Office Action Summary

10/780,723

SAITOH, HIROSHI

DETAILED ACTION

The Millet disclosure FIG. 1G. showing the lead frame.

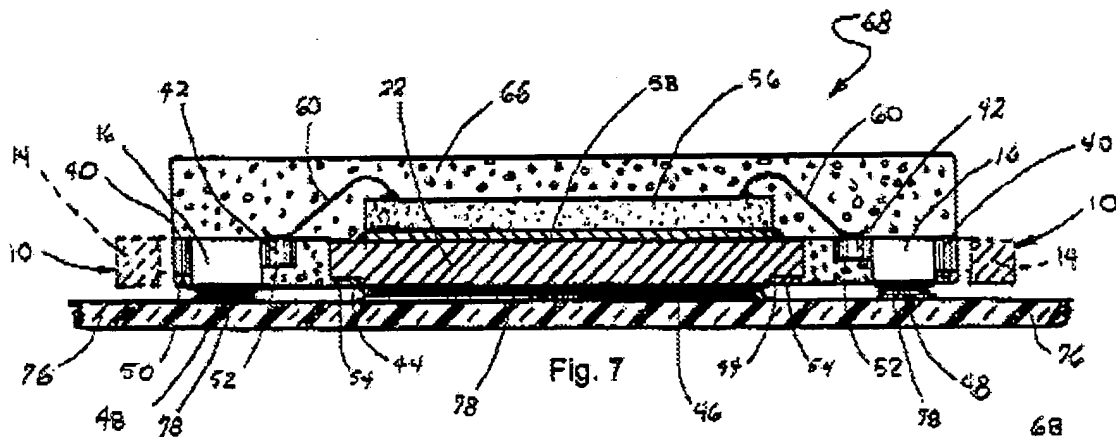
Millet in view of Perez discloses a semiconductor device substantially as claimed. See FIGS. 1A-8B of Millet and FIGS. 1-9 of Perez where the following limitations are disclosed.

The Perez disclosure showing resin 66.

6. Pertaining to claim 17, Millet discloses a manufacturing method for a semiconductor device comprising the steps of:

pressing a metal material 17 to produce a lead frame 28 that comprises a plurality of outer frames

17c and 17b, a plurality of electrode supports 17a connected with the plurality of outer frames,

and a plurality of electrodes 19 respectively supported by the plurality of electrode supports;

drawing the plurality of electrode supports to be lowered in position compared

with surfaces of the electrodes and at least a part of the outer frames;

forming a lead frame assembly in which a semiconductor chip (not shown) is electrically

connected with the plurality of electrodes. However, Millet fails to disclose

electrodes from each other. Perez discloses enclosing the lead frame assembly within a resin

package in such a way that the surfaces of the electrodes are exposed to a surface of the resin

package; and

cutting at least a prescribed part of the electrode supports so as to separate the plurality of

electrodes from each other. In view of Perez, it would have been obvious to one of ordinary skill

in the art to incorporate a resin into the semiconductor package of Millet because the resin forms

a protective body over the die (column 5, lines 30-35).
